NOTICE TO ALL CONTRACTORS:

Proposal #08: 2978-02-70, WISC 2021 261
Silver Spring Drive
N Long Island Dr to N Lydell Ave
Local Street
Milwaukee County

This is Addendum No. 02, which provides for the following:

ADDENDUM NO. 02

Addendum No. 02
ID 2978-02-70
Revised Sheet 5
April 2, 2021

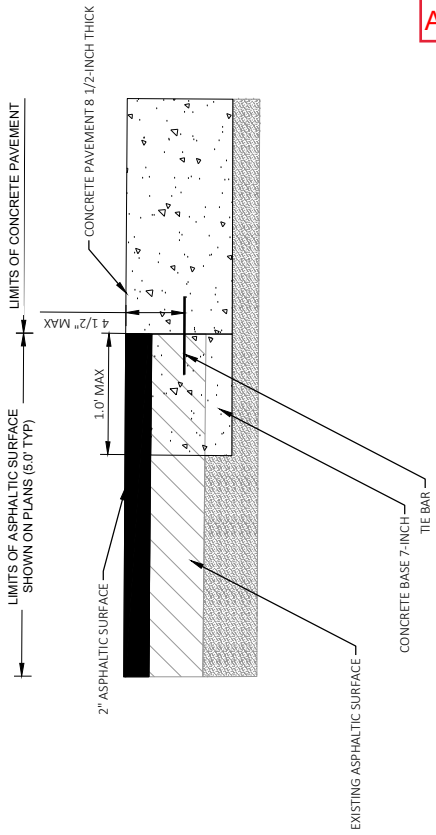
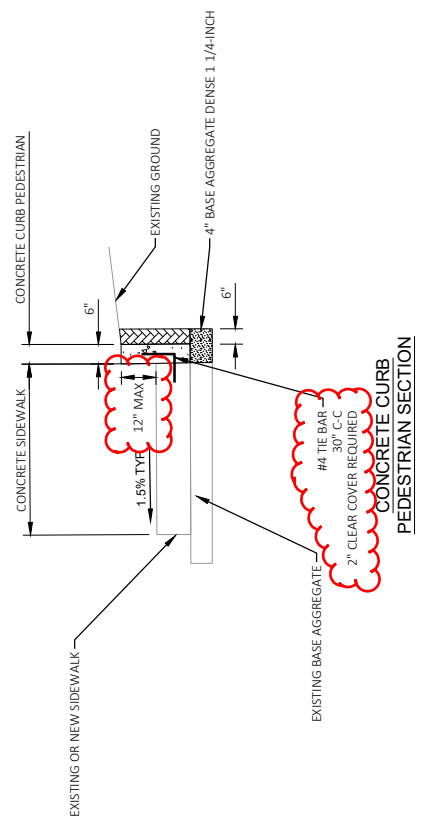
Revised Plan Sheets	
Plan Sheet	Plan Sheet Title (brief description of changes to sheet)
5	Construction Details – corrected detail notes
13	Traffic Control Notes – corrected Stage 1A note
145	Miscellaneous Quantities – removed and replaced Field Office quantity for corrected type
172	Plan – revised plan note.
173	Plan – revised plan note.
174	Plan – revised plan note.
